ADDENDUM NO. 1

RE: South Conway Lift Station Sanitary Sewer & Waterline Improvements
RFB # 20-179-03-12

You are hereby notified of the following changes to the plans, proposal, and/or specifications for the above-mentioned project.

E1 OF 1
© Copyright 2020 Melden & Hunt, Inc.
All Rights Reserved
File Name: ELECTRICAL PLAN
SHEET C16 OF 17

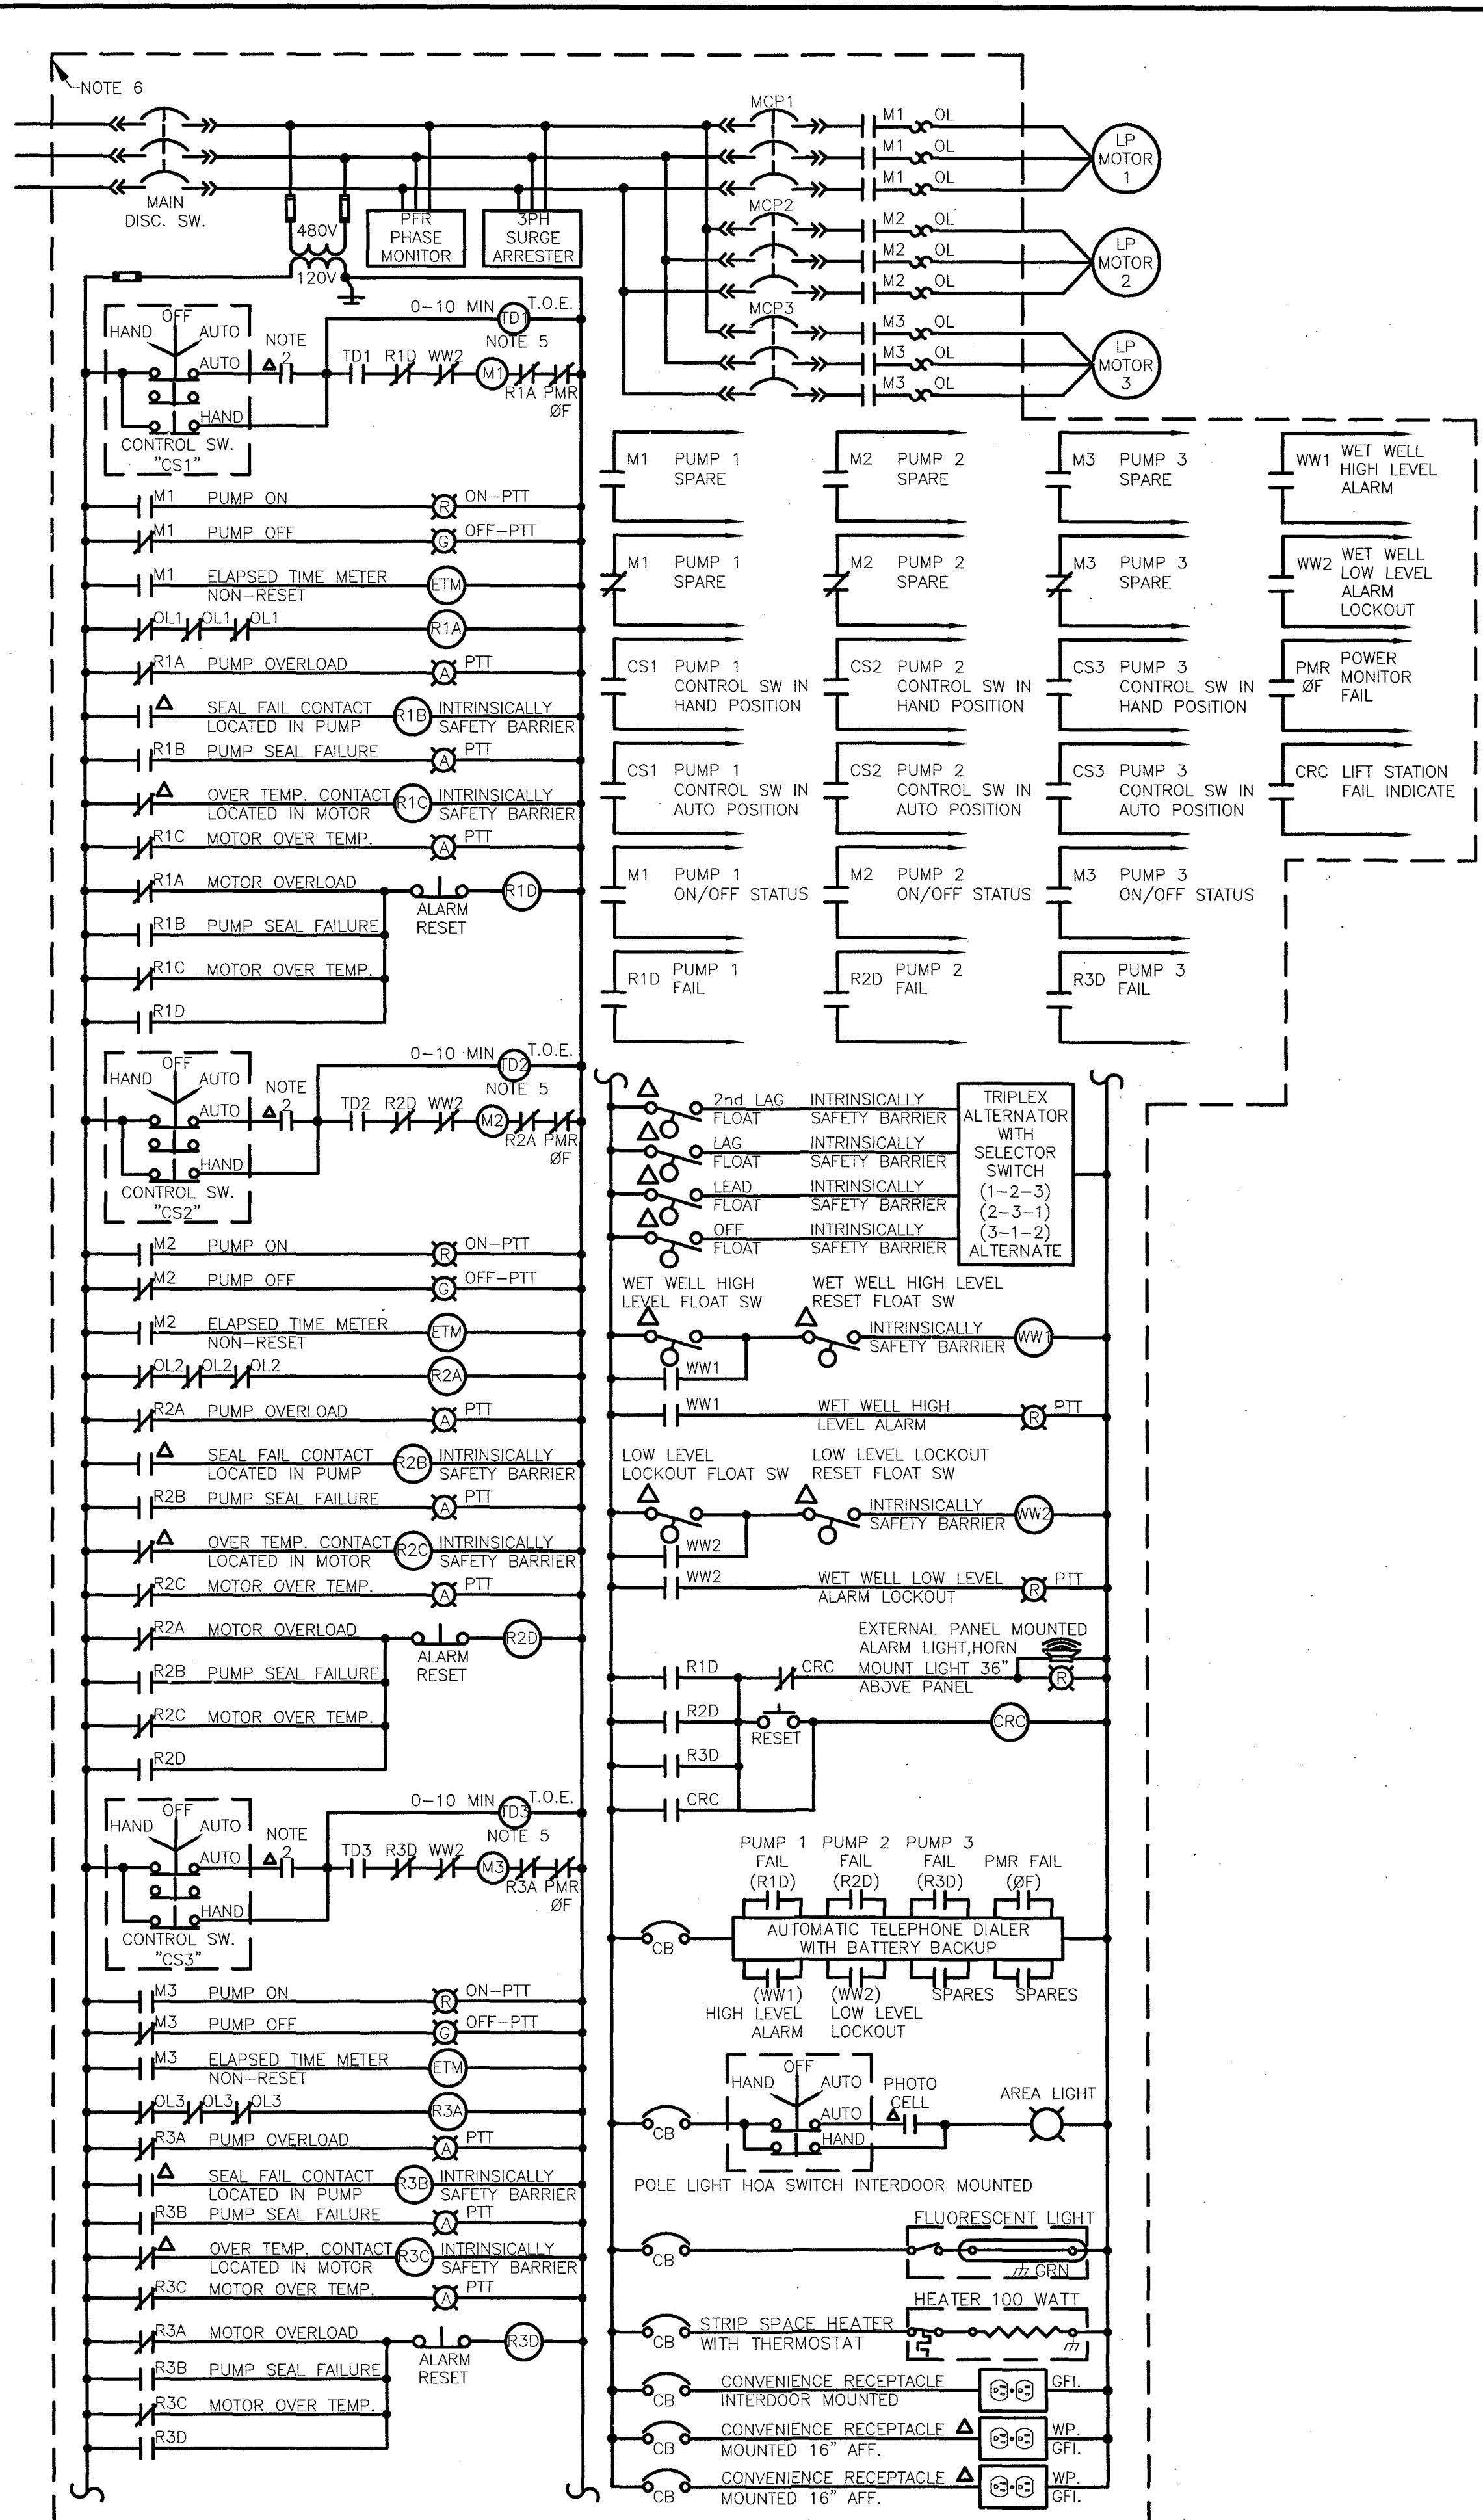
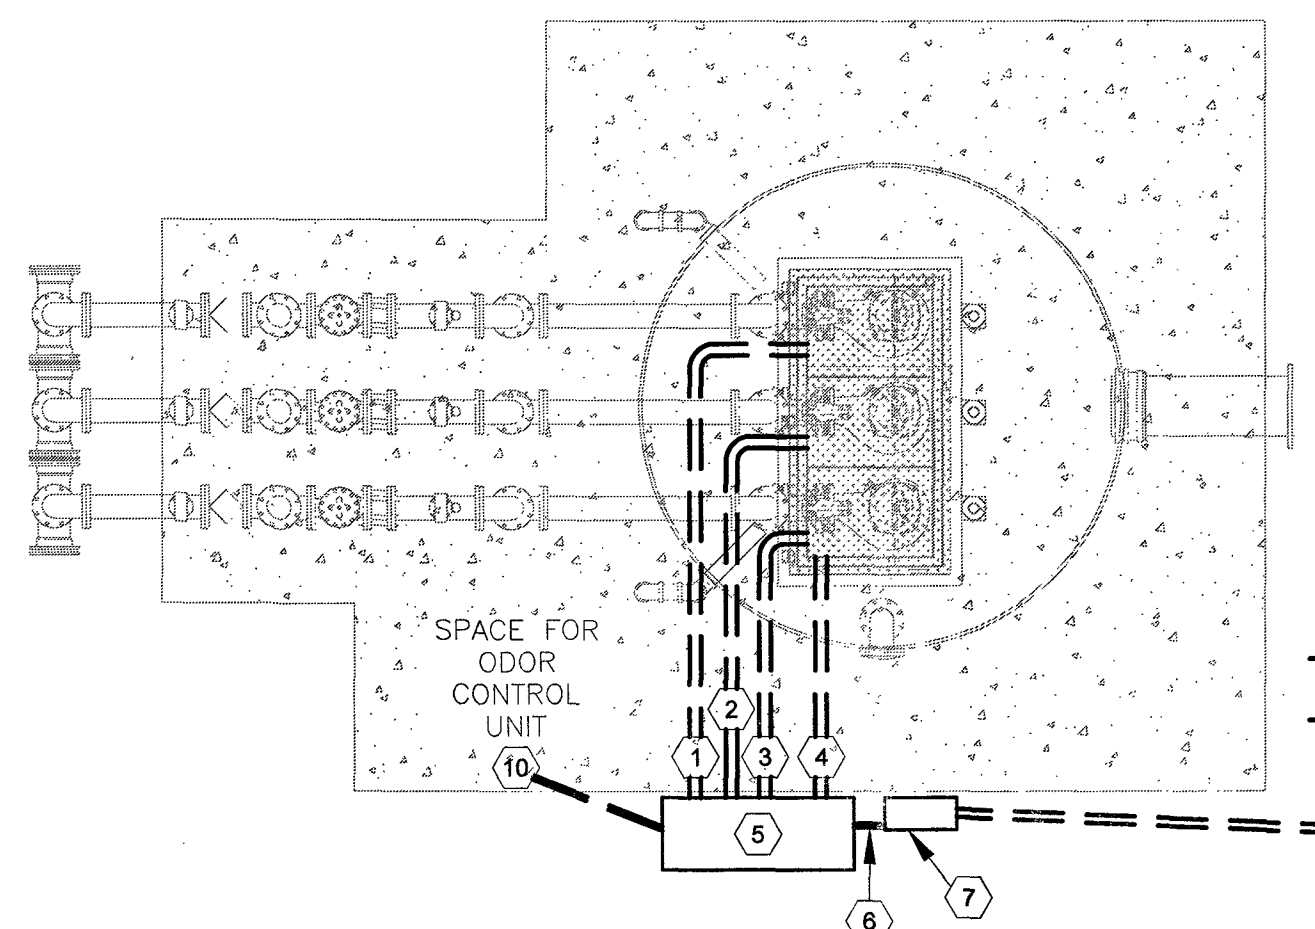
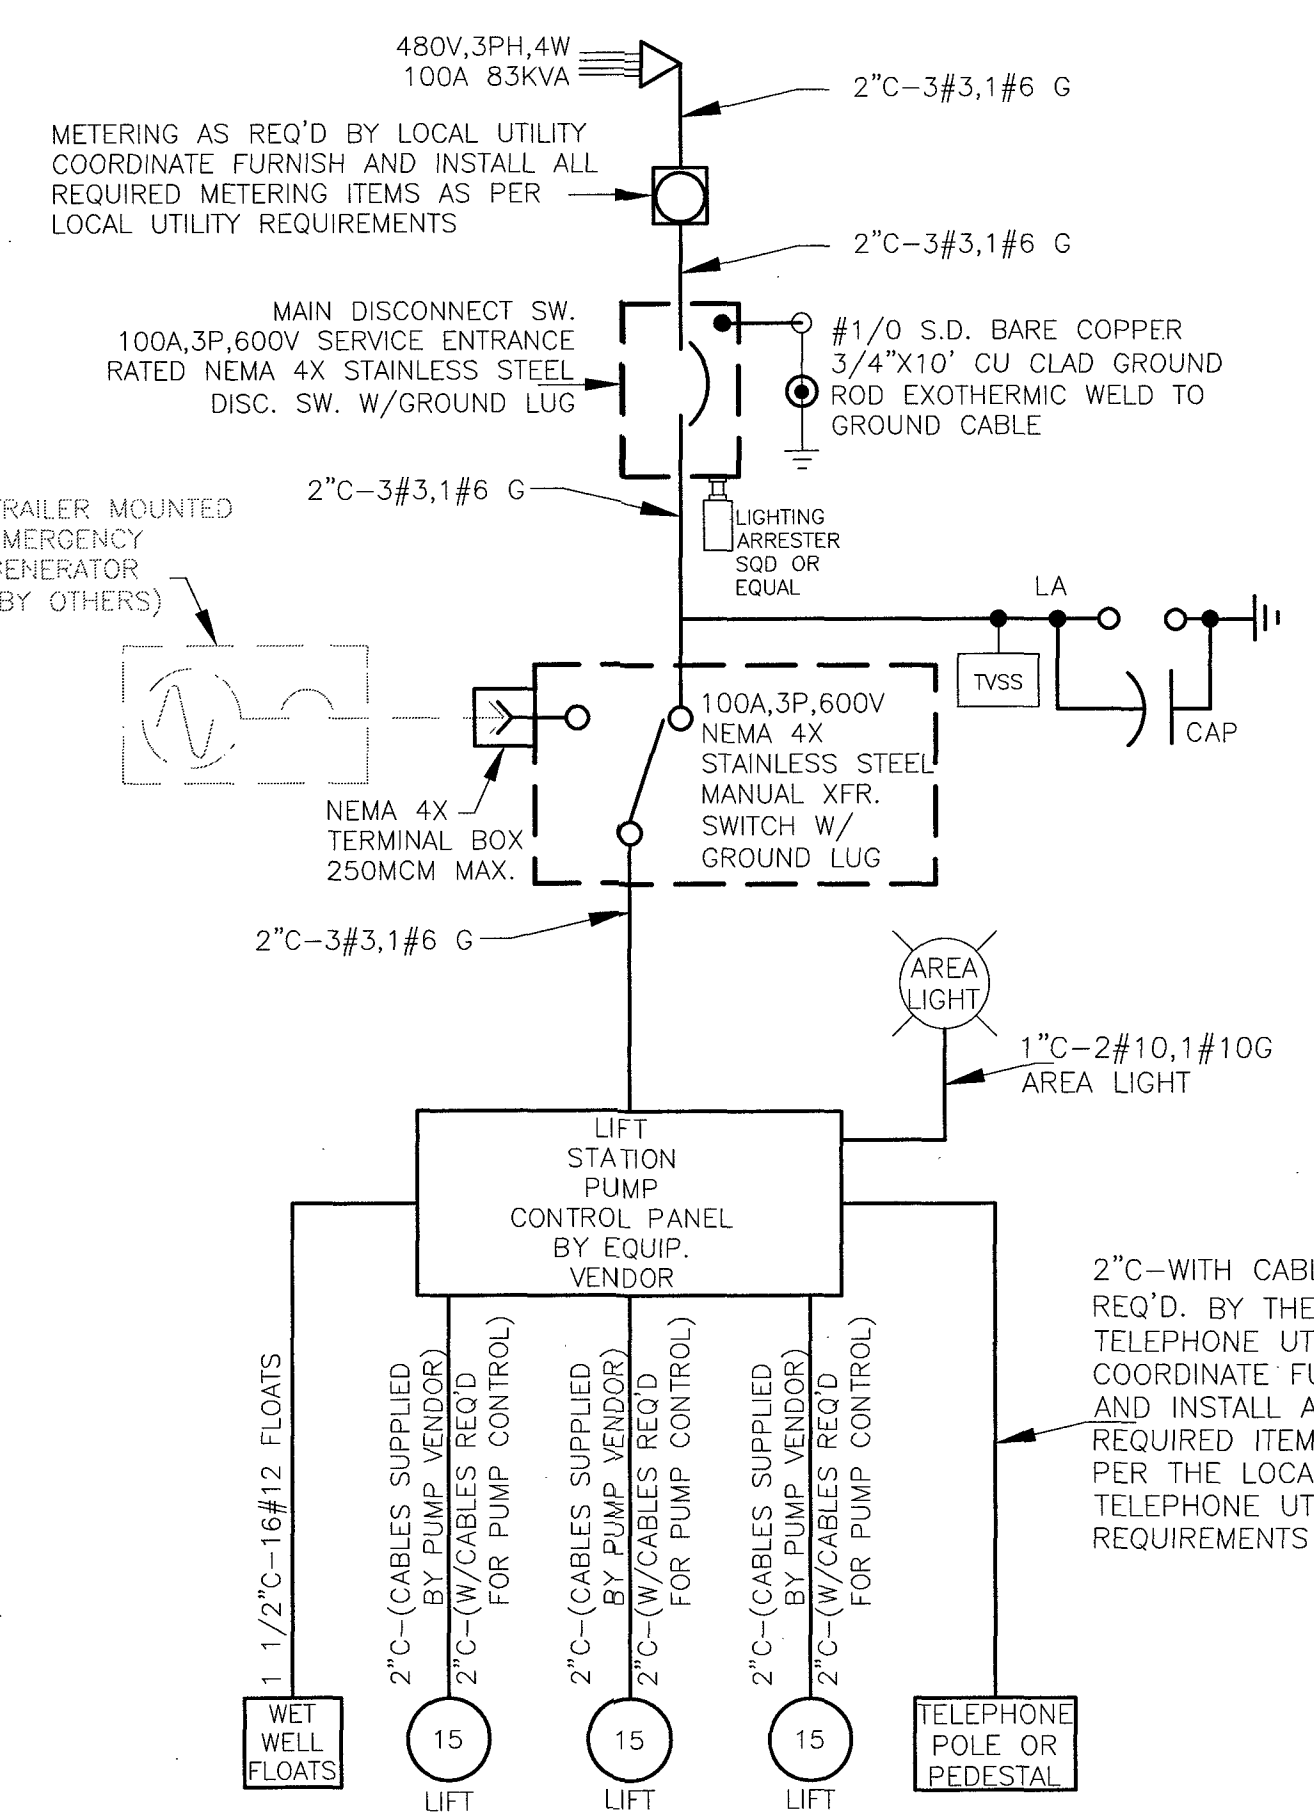
1. Sheet C6 has been revised to show the correct size of casing.
2. Sheet C10 has been revised to reflect proper fitting sizes.
3. Sheet C16 has been revised reflecting 3 submersible pumps.
